NUREG-1437  
Supplement 38, Vol. 4

# **Generic Environmental Impact Statement for License Renewal of Nuclear Plants**

### **Regarding Indian Point Nuclear Generating Units Nos. 2 and 3**

### **Final Report Supplemental Report and Comment Responses**

**Figure 4–3. Percentage of entrainment composed of RIS fish and total identified fish relative to the estimated total entrainment at IP2 and IP3 combined (data from Entergy 2007b)**

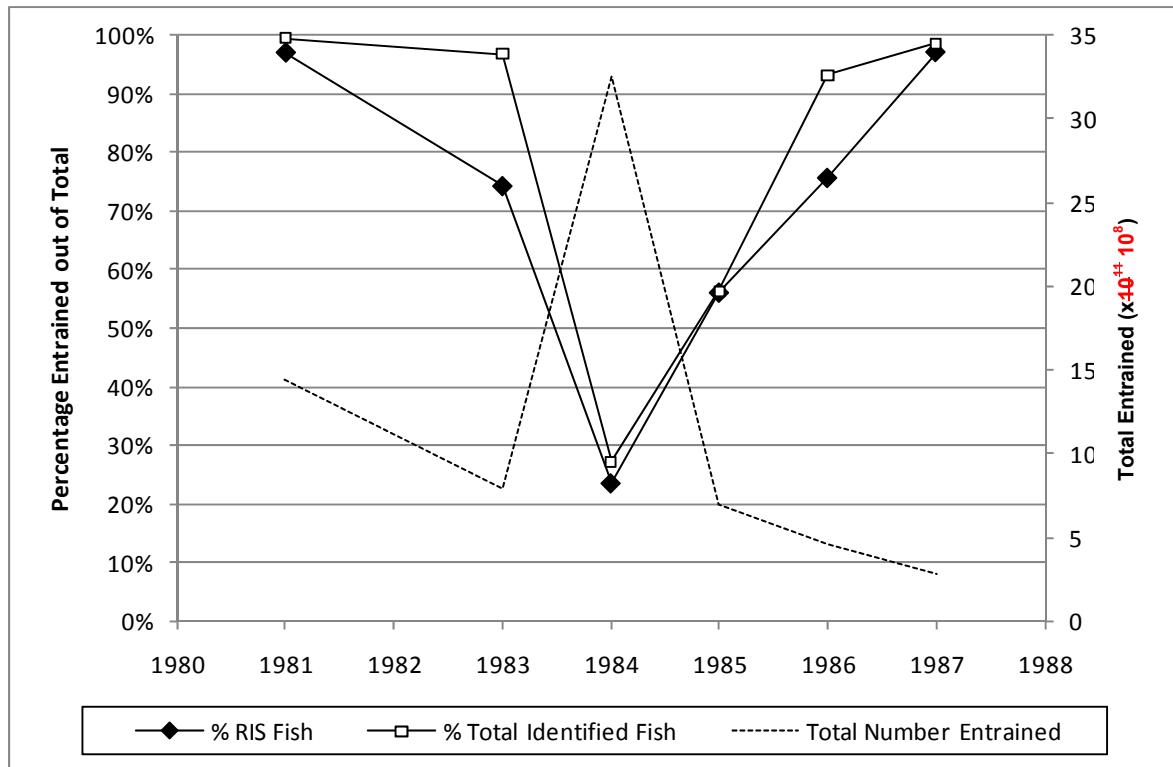
In the FSEIS, the NRC staff estimated the number entrained for a given week as the product of the mean density entrained and the combined weekly flow for IP2 and IP3. The error in the entrainment catch density directly affects Figure 4–3 in Section 4.1.2, and the error is repeated in Figure H–5 in Appendix H. In these figures, the total number entrained on the right axis should be in units of numbers  $\times 10^8$  instead of numbers  $\times 10^{11}$ . The corrected Figures 4–3 and H–5 appear below. In addition, these changes affect two portions of text in the FSEIS.

**Figure 4–3 on page 4-15** in the FSEIS is corrected as follows:

**Figure H–5.** Percentage of entrainment composed of RIS fish and total identified fish relative to the estimated total entrainment at IP2 and IP3 combined (data from Entergy 2007b)

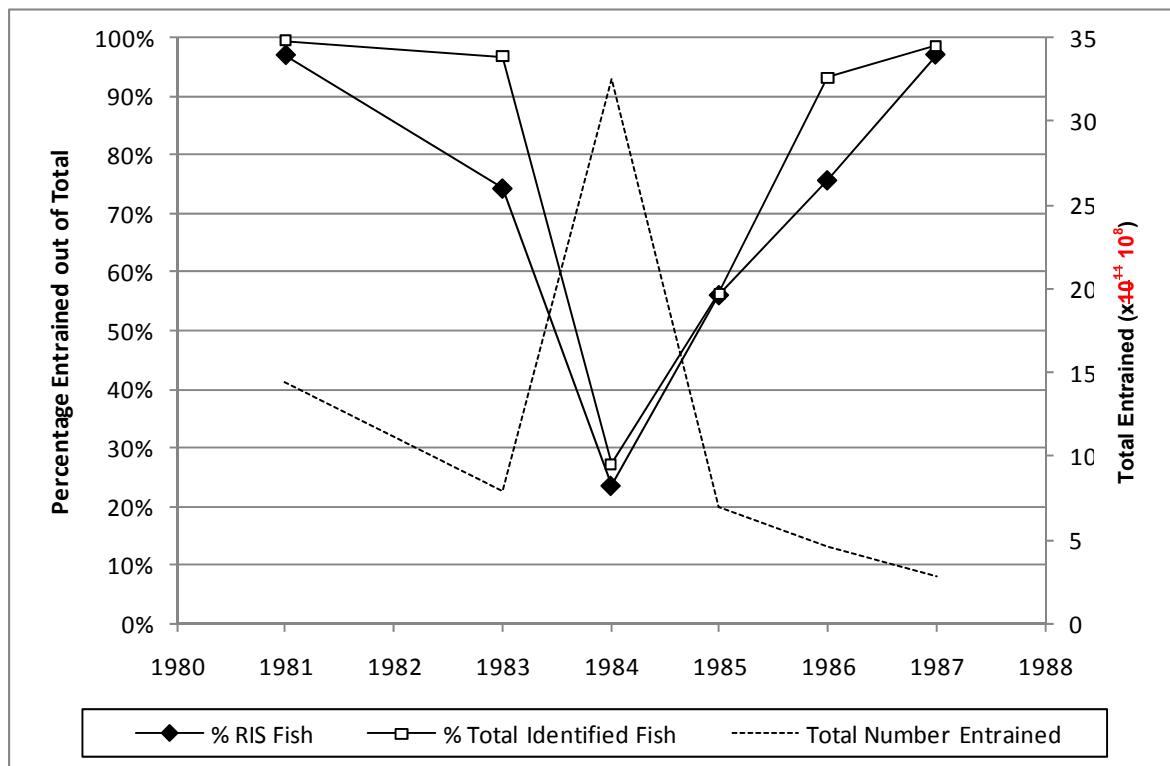
**Figure H–5 on page H-23** in the FSEIS is identical to Figure 4–3 in the FSEIS and is corrected as follows:
